ECE/TRANS/WP.29/2007/68  
16 July 2007

Proposal for the 04 series of amendments to Regulation No. 48

(Installation of lights and light-signalling devices)

Submitted by the Working Party on Lighting and Light-signalling

Model A

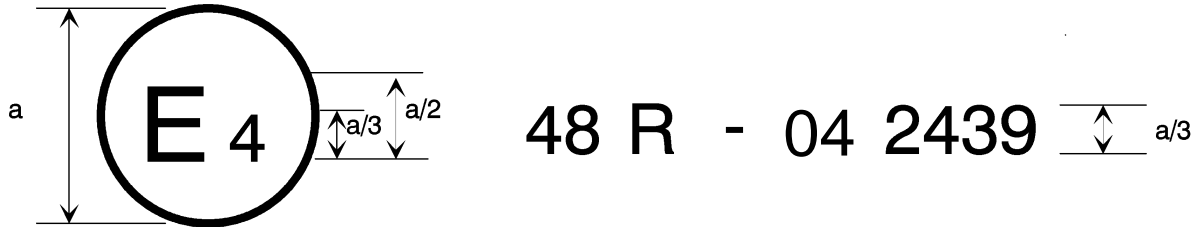
Annex 2, amend to read:

The above approval mark affixed to a vehicle shows that the vehicle type concerned has, with regard to the installation of lighting and light-signalling devices, been approved in the Netherlands (E4) pursuant to Regulation No. 48 as amended by the 04 series of amendments. The approval number indicates that the approval was granted in accordance with the requirements of Regulation No. 48 as amended by the 04 series of amendments.

Model B

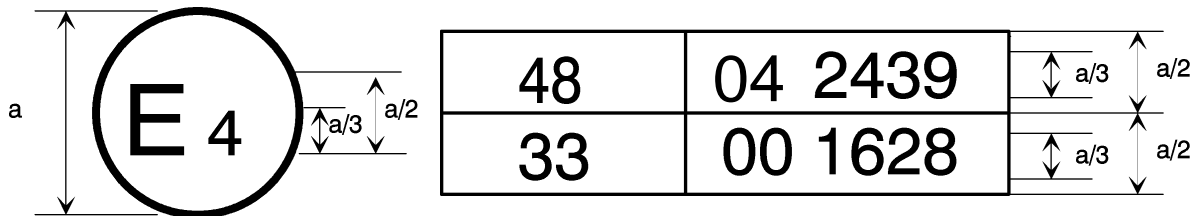
The above approval mark affixed to a vehicle shows that the vehicle type concerned has been approved in the Netherlands (E4) pursuant to Regulation No. 48 as amended by the 04 series of amendments and Regulation No. 33. 1/ The approval number indicates that, at the dates when the respective approvals were given, Regulation No. 48 was amended by the 04 series of amendments and Regulation No. 33 was still in its original form.
